SAN FRANCISCO PLANNING DEPARTMENT

Re: Responses to Comments on an EIR for the 801 Brannan and One Henry
Adams Streets Project and draft EIR Certification Motion
Case File No. 2000.618E

Planning Department Case No. 2000.618E

801 Brannan Site — Adjacent Land Uses Revised Figure 23

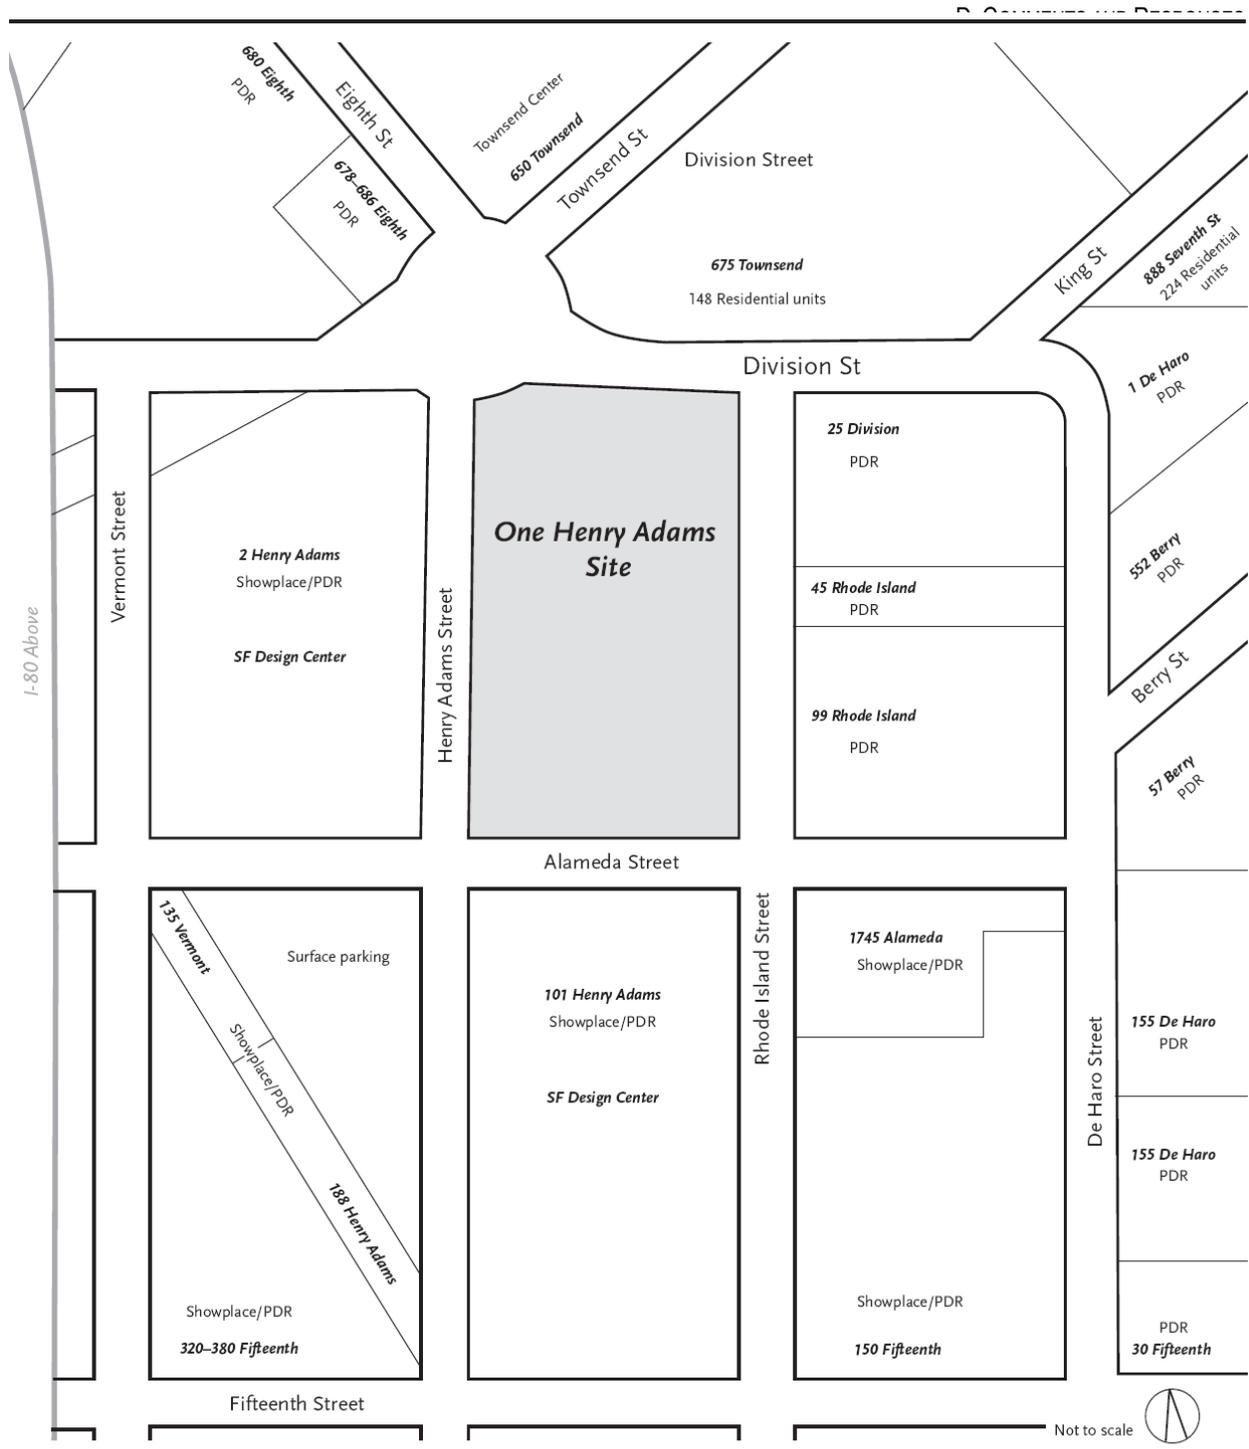
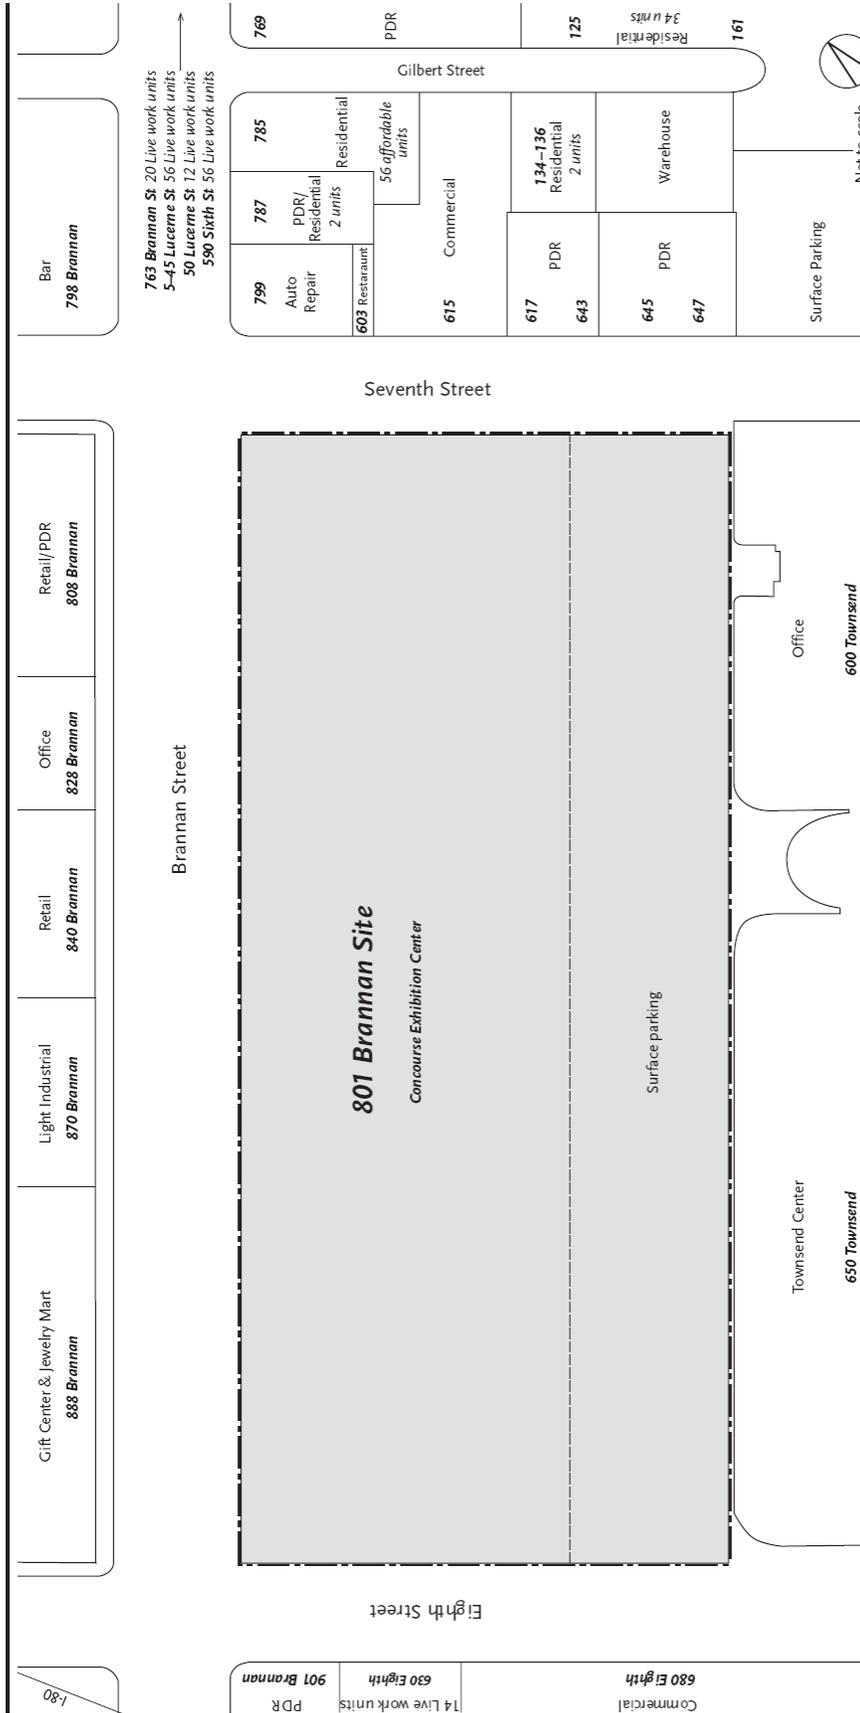
“On page 84 reference is made to Figure 23 on page 76, which purports to show the location of ‘Residential buildings in the project vicinity.’ Figure 23 only shows the 801 Brannan Street site and the immediate properties surrounding it. This figure should be reworked to show all the properties identified as residential, including those near One Henry Adams Street, with their respective addresses, number of units and unit mix. This would help to illustrate that the project would be compatible with surrounding and planned uses.” (*Hisashi Sugaya, Planning Commissioner, Comment Letter B, 1st comment*)

The comment requests additional information be provided on Figure 23, 801 Brannan Site – Adjacent Land Uses, and that a new figure be provided that shows comparable information for the One Henry Adams site. Figure 23 on page 76 of the Draft EIR has been revised to show the number of units associated with residential use surrounding the 801 Brannan site as identified on page 77 of the Draft EIR. This figure has been renamed Revised Figure 23 and is shown in this document on the following page. In addition, a new Figure 24A is added to the Draft EIR. This figure, shown on page RTC 80, indicates the number of units associated with residential uses surrounding the One Henry Adams site as discussed on page 78 of the Draft EIR.

Land Use Section of the Draft EIR, Page 76, Figure 23 is replaced by Revised Figure 23 on page RTC 79.

801 Brannan Site — Adjacent Land Uses Revised Figure 23

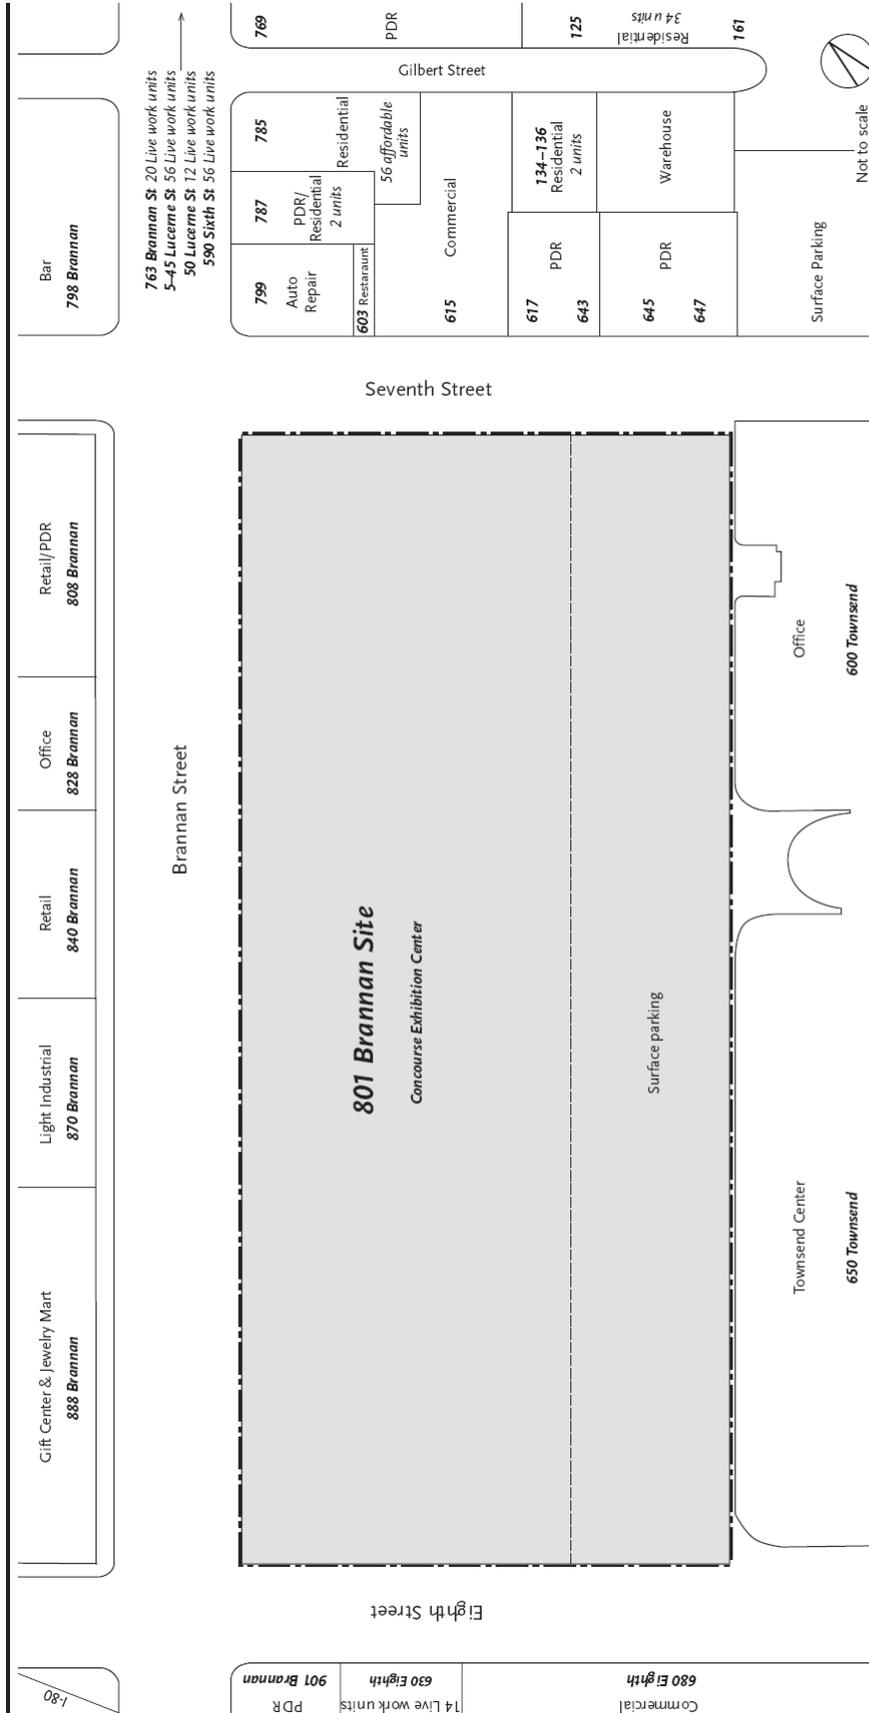
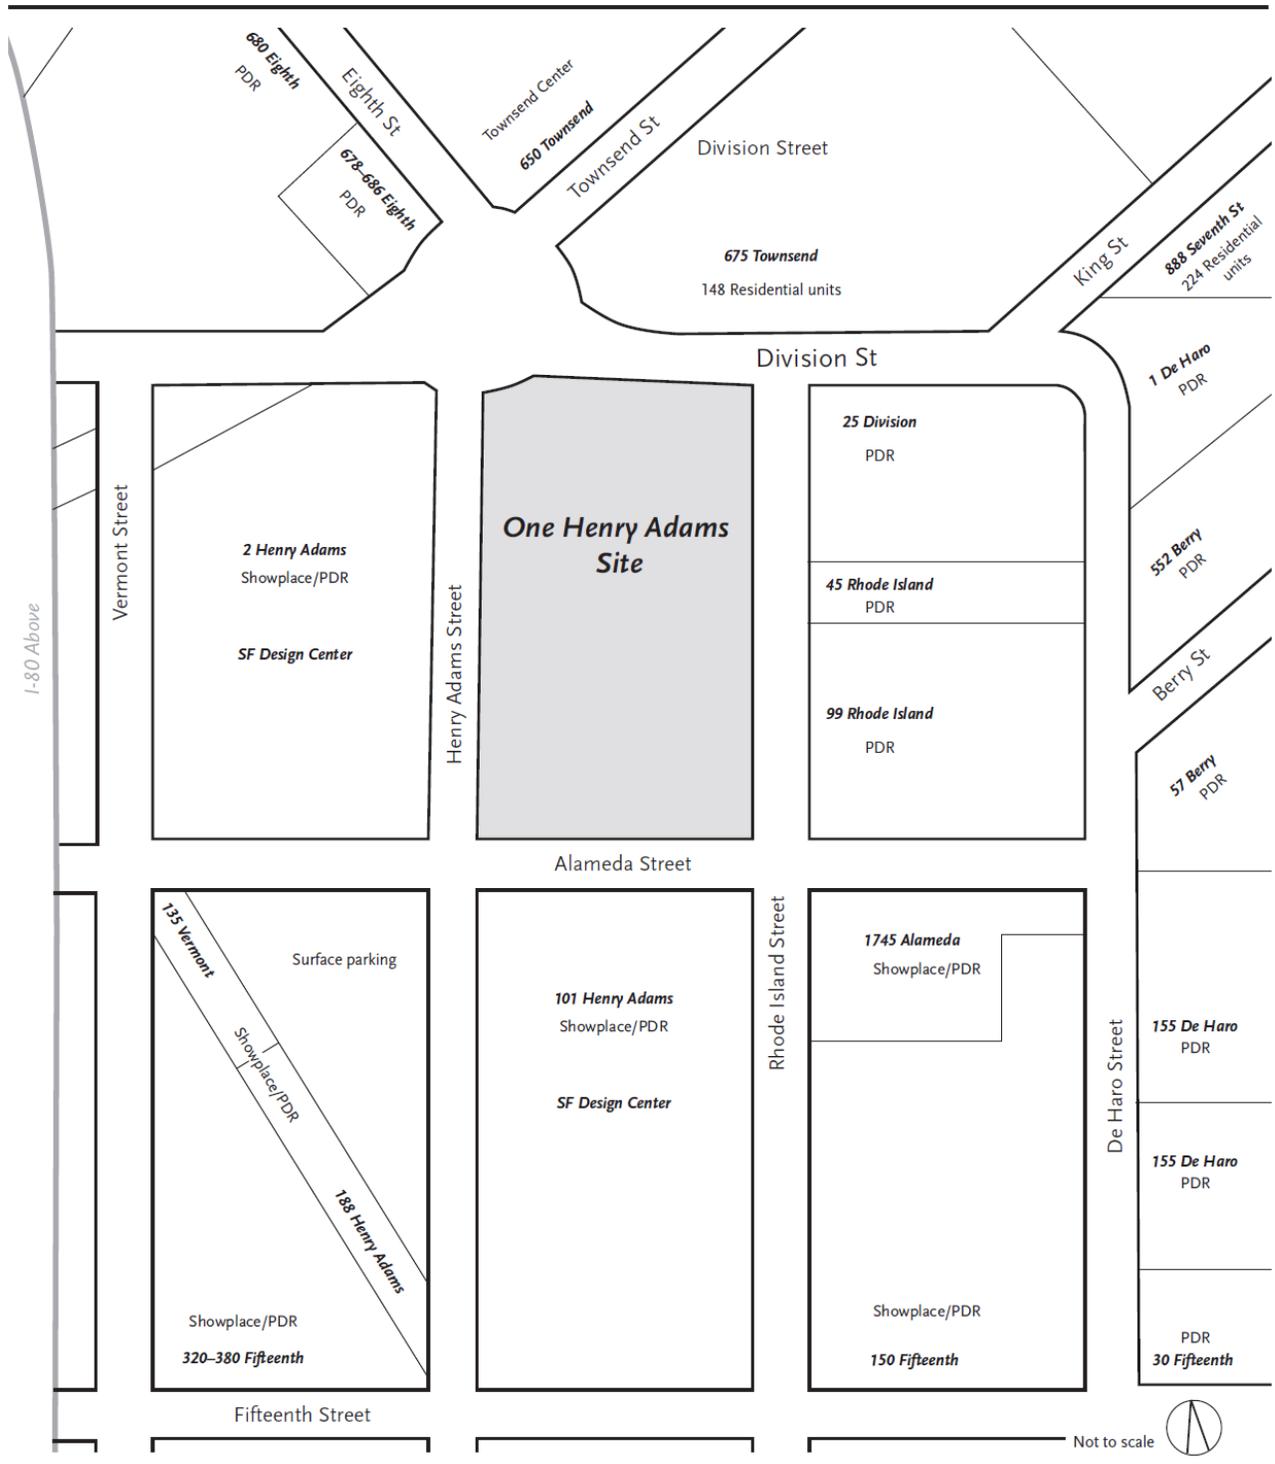
On page 84 reference is made to Figure 23 on page 76, which purports to show the location of "Residential buildings in the project vicinity." Figure 23 only shows the 801 Brannan Street site and the immediate properties surrounding it. This figure should be reworked to show all the properties identified as residential, including those near One Henry Adams Street, with their respective addresses, number of units and unit mix. This would help to illustrate that the project "would be compatible with surrounding and planned uses."

Page 76, Figure 23 is replaced by Revised Figure 23 on page RTC 142.

New page 79a, New Figure 24A on page RTC 143 is inserted.
